Rev	Description	Date
A	Initial Release	12/96
B	1. Rad41 through Rad420 added to increase LED drive to 25mA 2. R60, R61, R62, R63, R64 changed to 39.2K to increase I/V gain for new OSEMs.	8/01
B1	R60, R61, R62, R63, R64 may be changed to 29.4K for operation on CIT 40 M.	2/04
B2	Added note about need for satellite amplifier termination board (D990021-00)	1/05

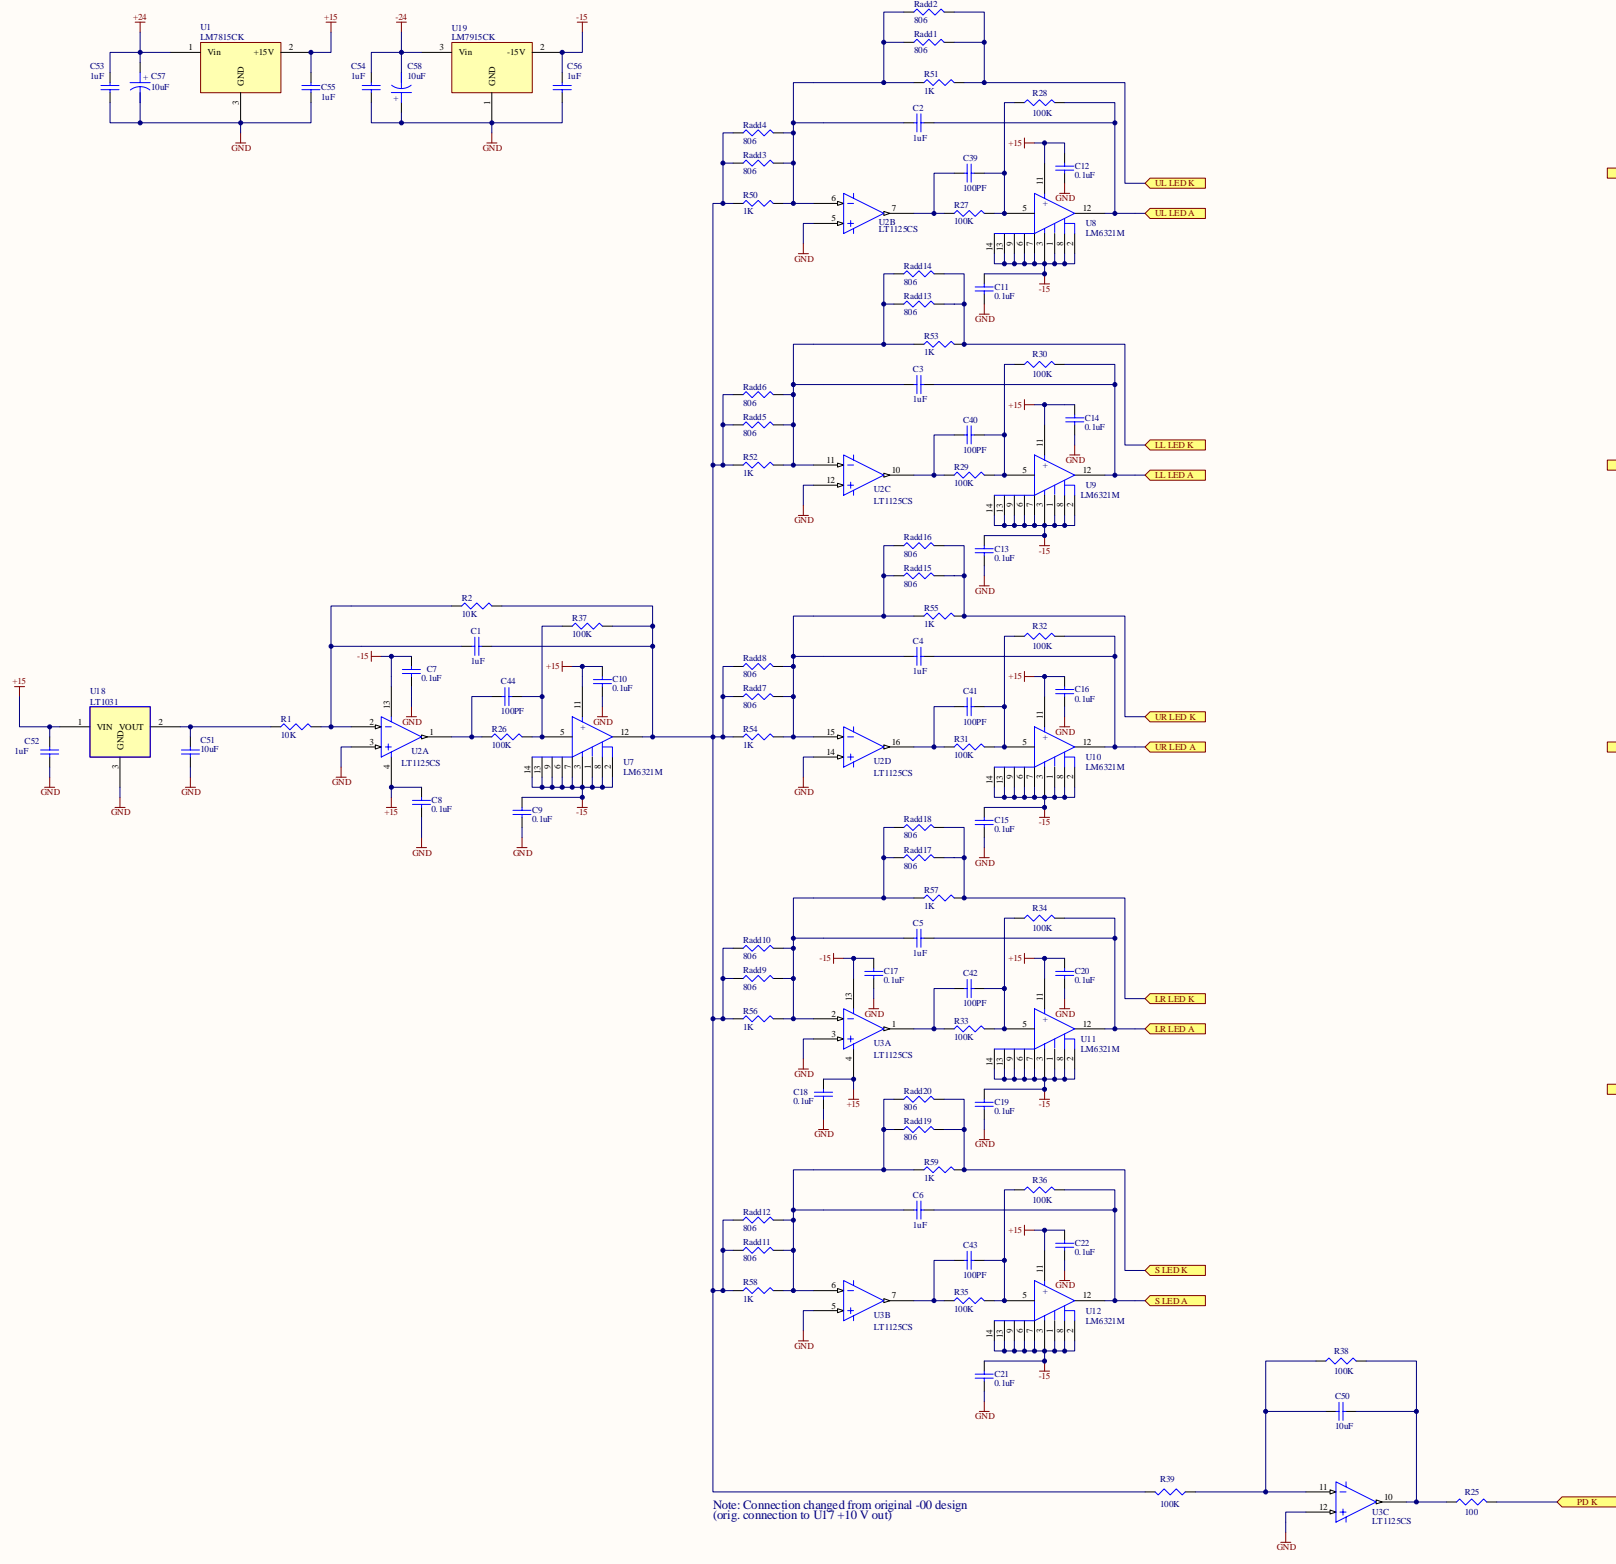
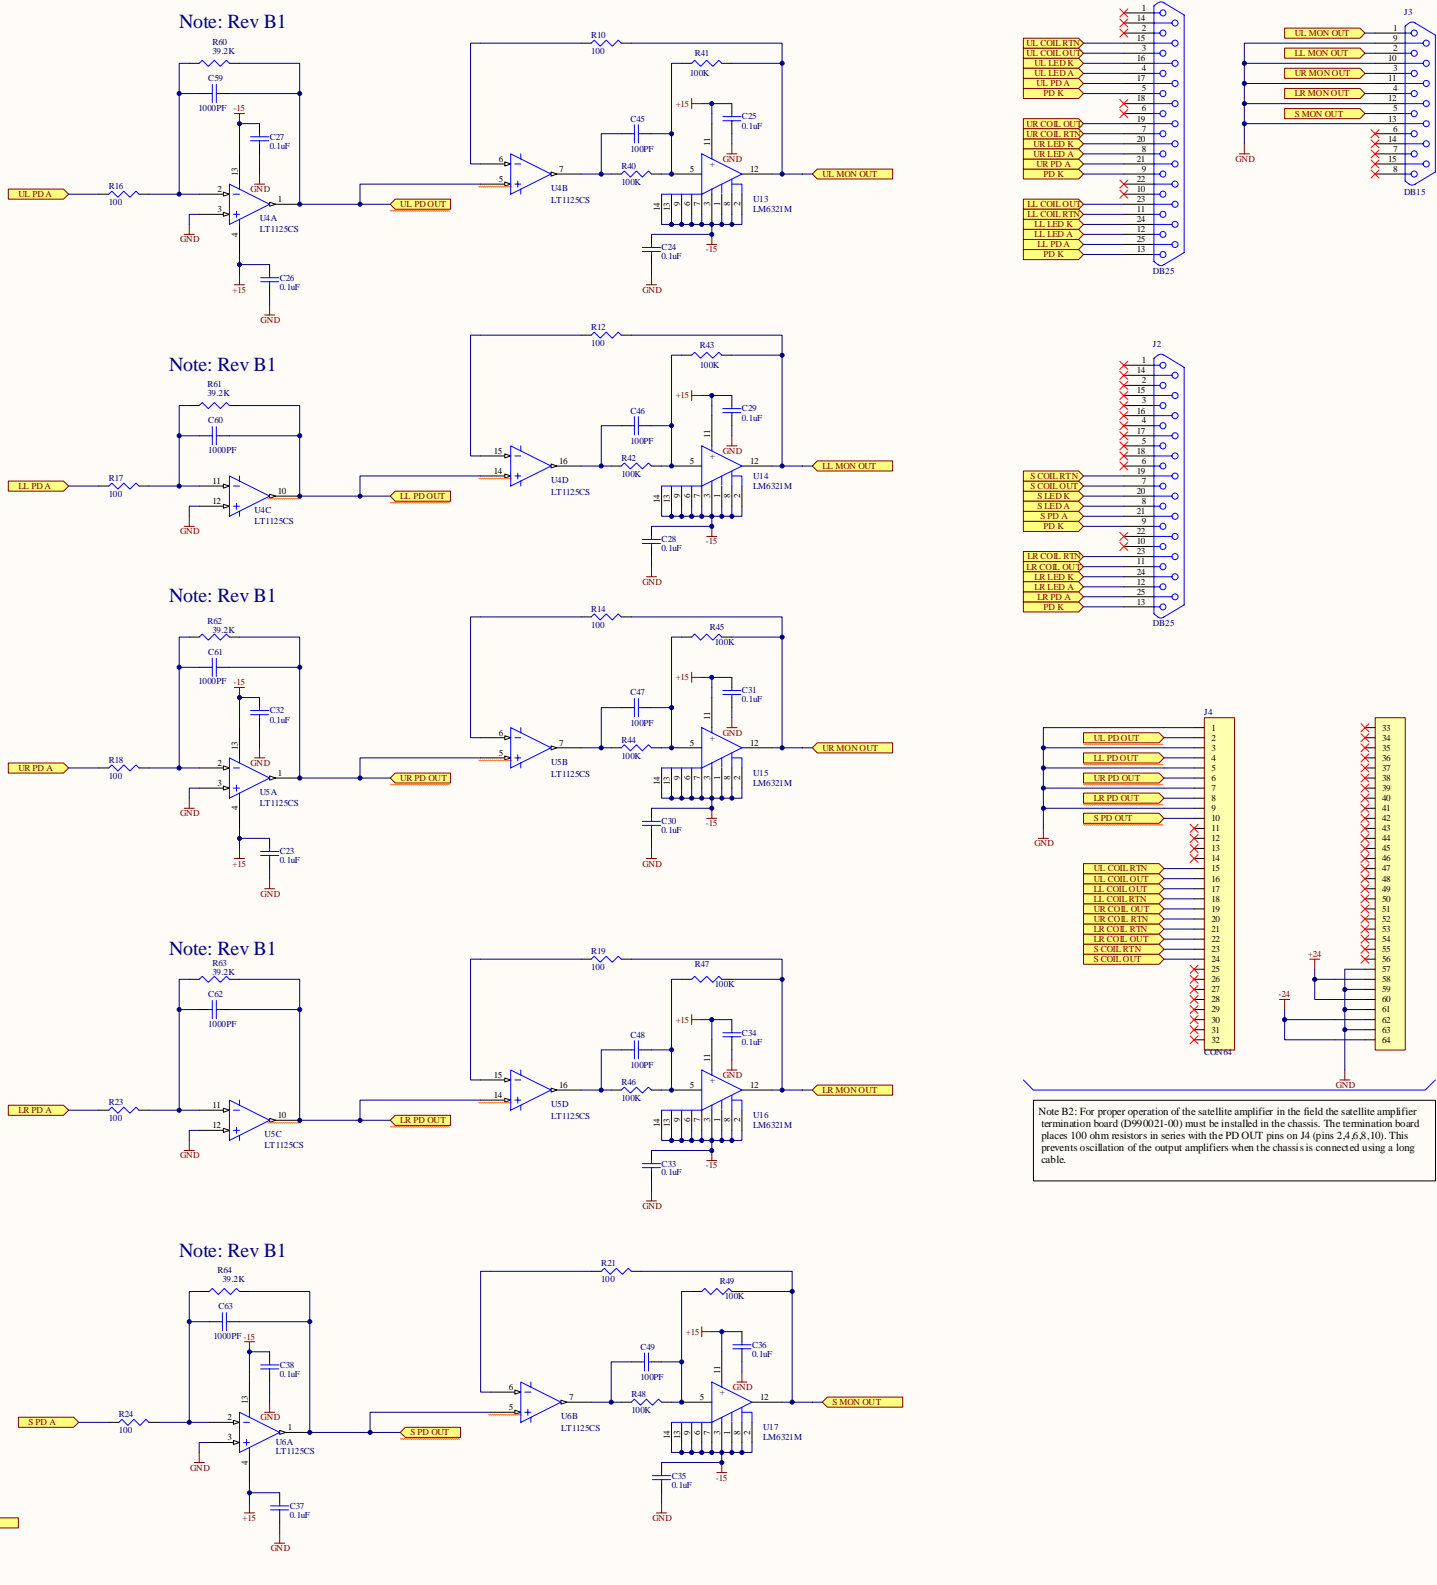
LED drive current = 25mA

Note: Connection changed from original -00 design (orig. connection to U17 +10 V out)

Note: Rev B1

Note: Rev B1

Note: Rev B1

Note: Rev B1

Note: Rev B1

Note B2: For proper operation of the satellite amplifier in the field the satellite amplifier termination board (D990021-00) must be installed in the chassis. The termination board places 100 ohm resistors in series with the PD OUT pins on J4 (pins 2,4,6,8,10). This prevents oscillation of the output amplifiers when the chassis is connected using a long cable.
